P 366P3
A REPAIR

SEWAGE DISPOSAL SYSTEM

HOWARD COUNTY
BUREAU OF ENVIRONMENTAL HEALTH
461-9933

SUBDIVISION _____ ROAD 3546 Church Road LOT _____

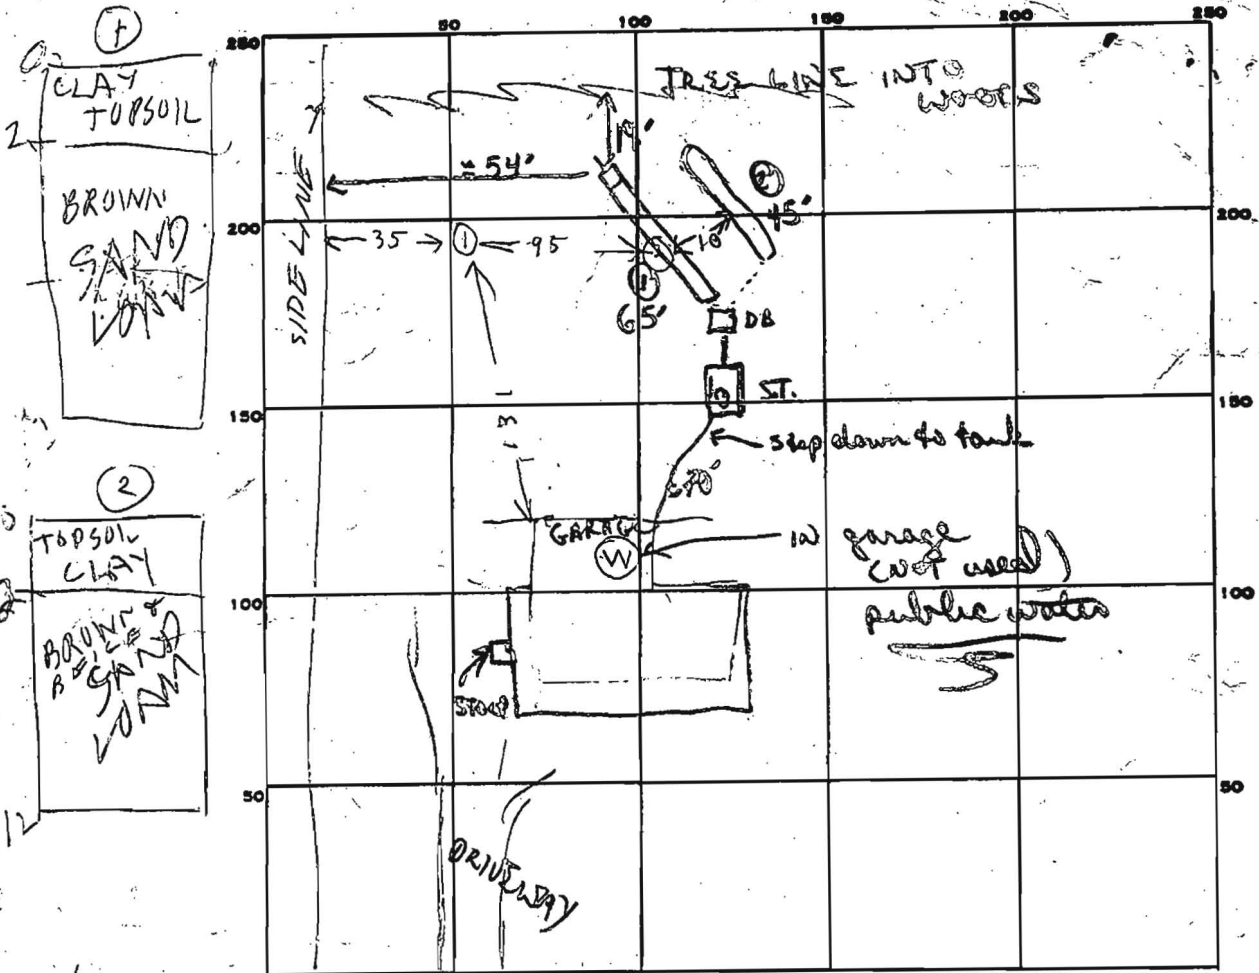
RECOMMEND REPAIR. 3/13/86 TRENCH 9 FT DEEP INLET

1/2 FT - 3 FT DEEP 6-6 1/2 FT STONE, 113 FT LONG (170 SQ FT SIDEWALL AREA PER RR) 2 FT WIDE PLACE THE TRENCH BETWEEN THE 2 PERC HOLES LOCATED 130-140 FROM THE GARAGE, PLACE THE TANK 75 FT FROM THE WELL IN THE GARAGE RA

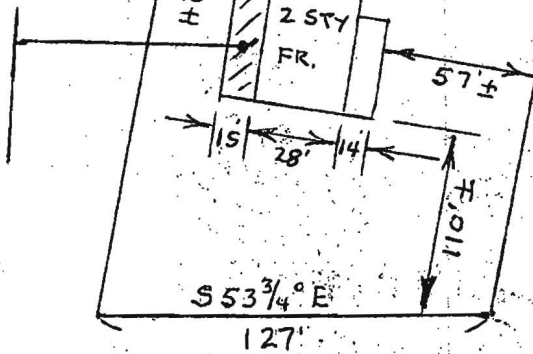
NO EXISTING SEPTIC SYSTEM

SUCCESSFUL PERM.
TANK INSTALLED,
TRENCHES TO BE
ADDED SHORTLY,
OK TO PROCEED *Challen*
